## **Planning Board Agenda**

- 1. Call to Order**
- 2. Roll Call**
- 3. Approval of Minutes**
  - A. Approve April 19, 2023 minutes
- 4. General Public Comments**
- 5. New Business**
  - A. Public Hearing for Mountain View Subdivision
- 6. Old Business**
- 7. Board Comments**
- 8. Adjournment**

**A. APRIL 19, 2023 MEETING MINUTES**

Figure 1. Development Plan

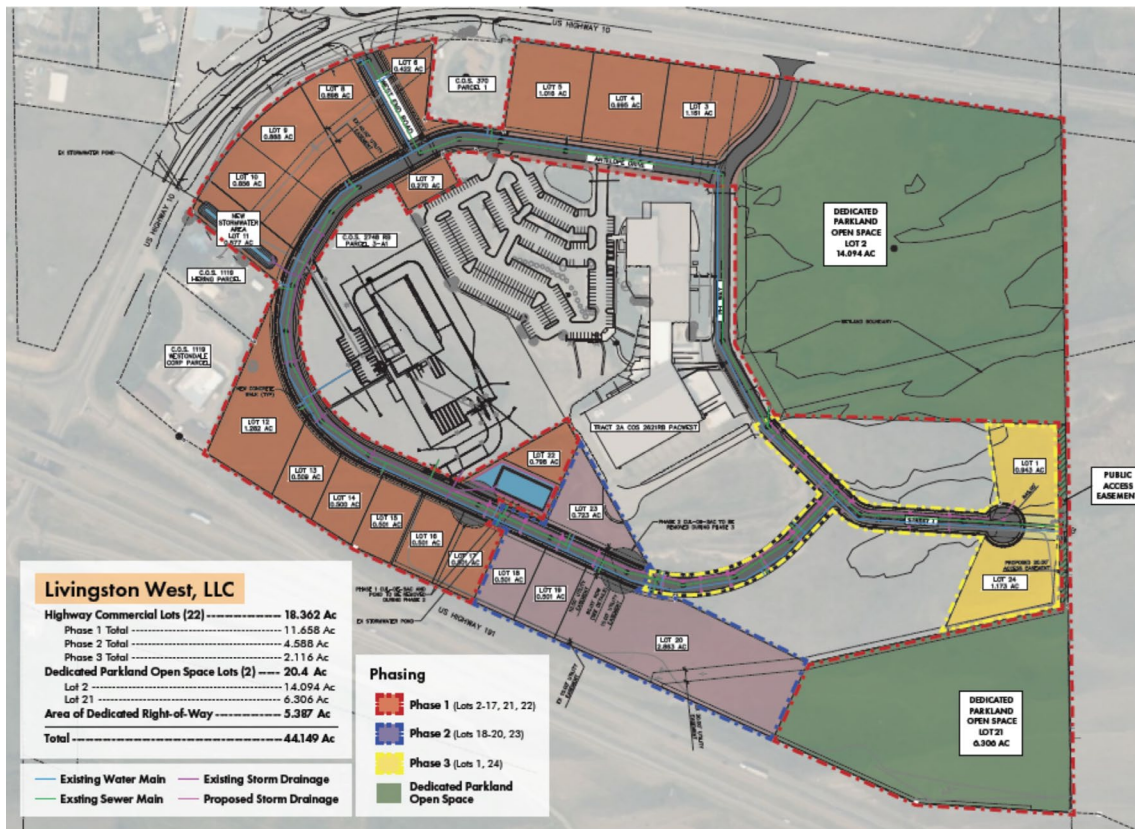
**Livingston Public Works-** comments were provided about the following: additional costs to the City associated with the proposed subdivision; street improvements and temporary safety measures between phase development; erosion control; water and sewer connection requirements for each subdivided lot; ownership and maintenance responsibilities for new public facilities; and staff review of stormwater and street plans for phases 2 and 3. Recommendations were made for: a new sewer main near Kenyon Noble as recommended in the Wastewater Preliminary Engineering Report;

**Livingston Fire and Rescue-** no concerns; approve of the new line extensions for many of the hydrants shown on the plans.

*An all-weather access road between Antelope Drive and PFL Way must be constructed as part of Phase 1 improvements to provide maintenance and emergency access until future phases and streets are constructed to complete the internal road network. The Public Works director has requested the applicant provide dead end barricades at the cul de sacs for each phase of development to prevent the public from accessing the all-weather road.*

12. The applicant must install provide dead end barricades at the cul de sacs for each phase of development to prevent the public from accessing the all-weather road.

13. An all-weather access road between Antelope Drive and PFL Way must be constructed as part of Phase 1 improvements to provide maintenance and emergency access until future phases and streets are constructed to complete the internal road network.
